SUBJECT: COMANCHE PEAK STEAM ELECTRIC STATION
RESPONSES TO Q251.1 THRU Q251.4

Attached is a rough draft of the responses to NRC Questions 251.1 thru Q251.4 for your early review. These responses will be included in Amendment 24, scheduled to be submitted on July 15, 1981.

Ques-251.1
Q-251.1

CPSES / FSAR
TABLE 3.5-7

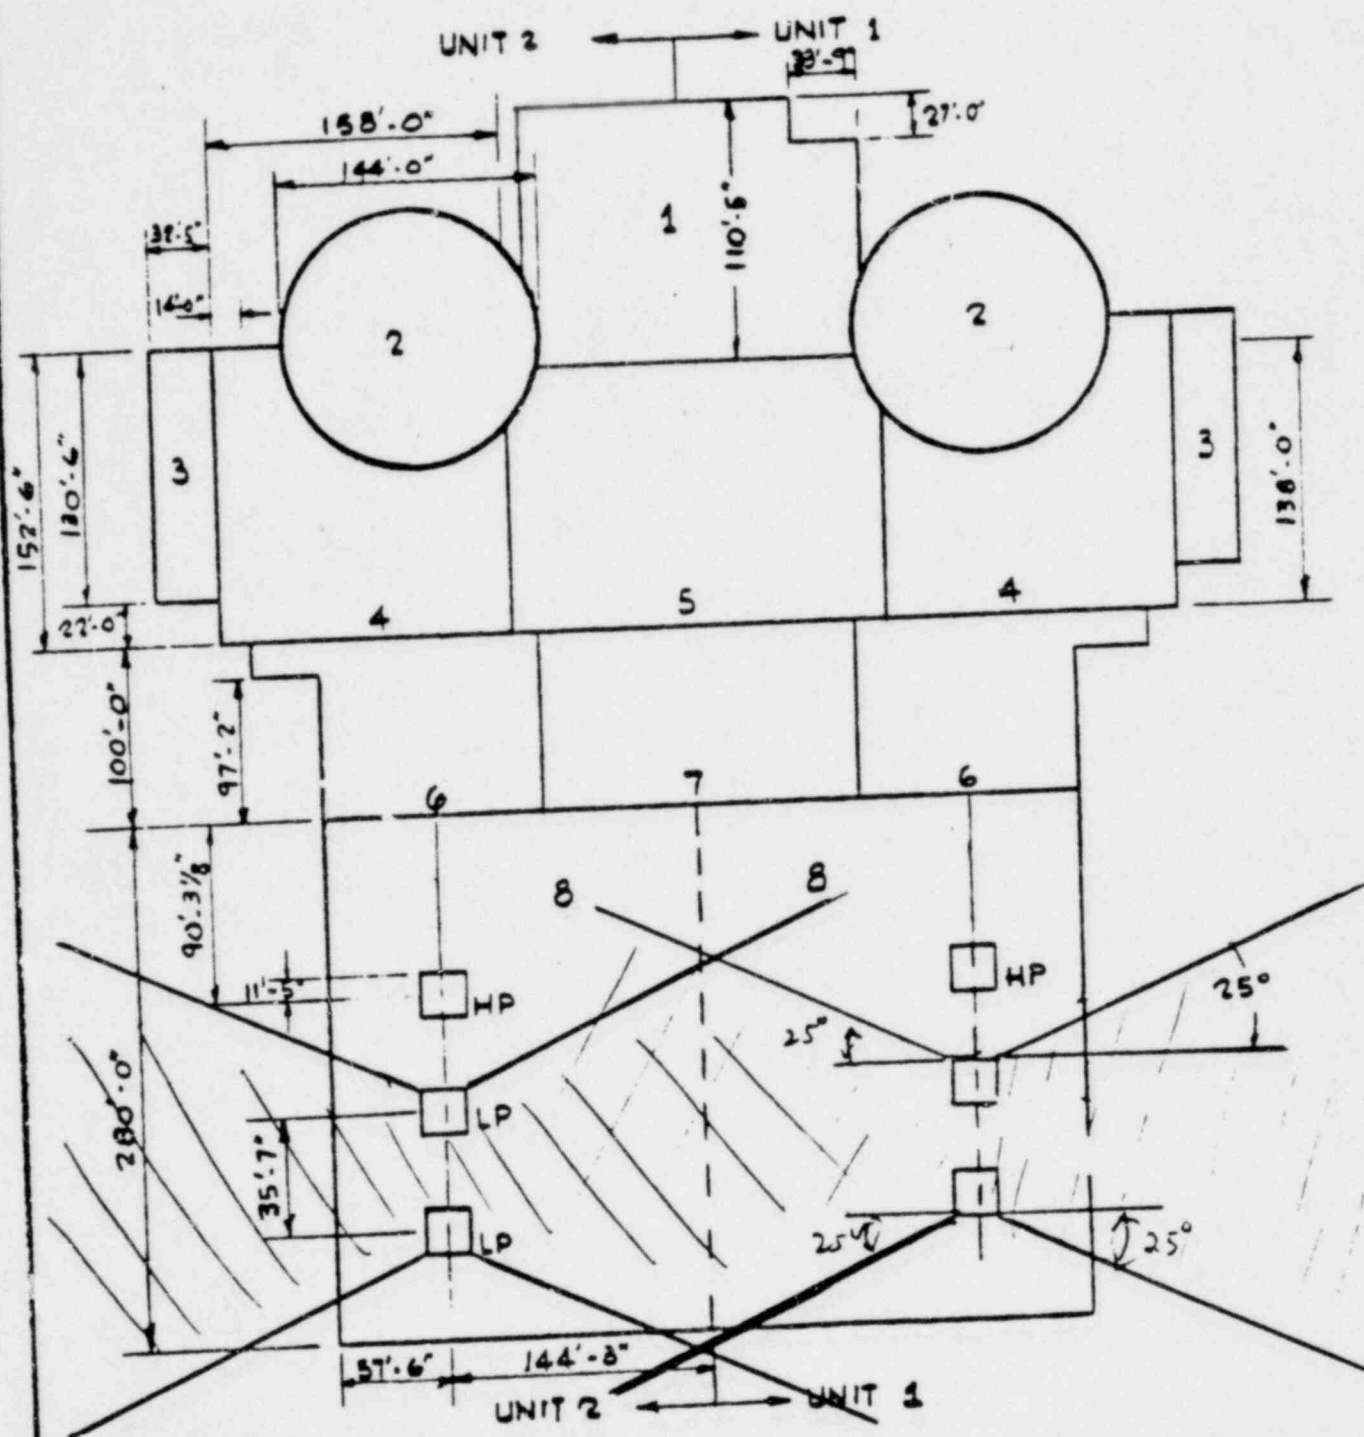
The values of P shown in Table 3.5-7 are unacceptable; the values currently accepted by the NRC staff are 5×10^{-5} and 4×10^{-5} per turbine year for design and destructive overspeed failures, respectively (see Standard Review Plan Section 3.5.1.3).

To be conservative, and due to lack of information, the values of P are generally taken to be one. If other values are used, such as those shown in Table 3.5-7, appropriate equations must be derived and/or the values obtained for each target must be justified to the NRC staff.

The $P_2 \times P_3$ probabilities in Table 3.5-7 appear to be too small.

Re-calculate the $P_2 \times P_3$ probabilities associated with each safety related target for design overspeed, and destructive overspeed,

and show that the total $P_2 \times P_3$ for each of these failures conditions is less than 10^{-3} per failure, as stipulated in Regulatory Guide 1.115.

Prepare a table showing the $P_2 \times P_3$ probabilities for each target.

See revised Table 3.5-7.

The combined strike and damage probability (P2 x P3) for all targets is 3.6×10^{-4} and it is within the NRC criterion of 10^{-3} per turbine failure [10].
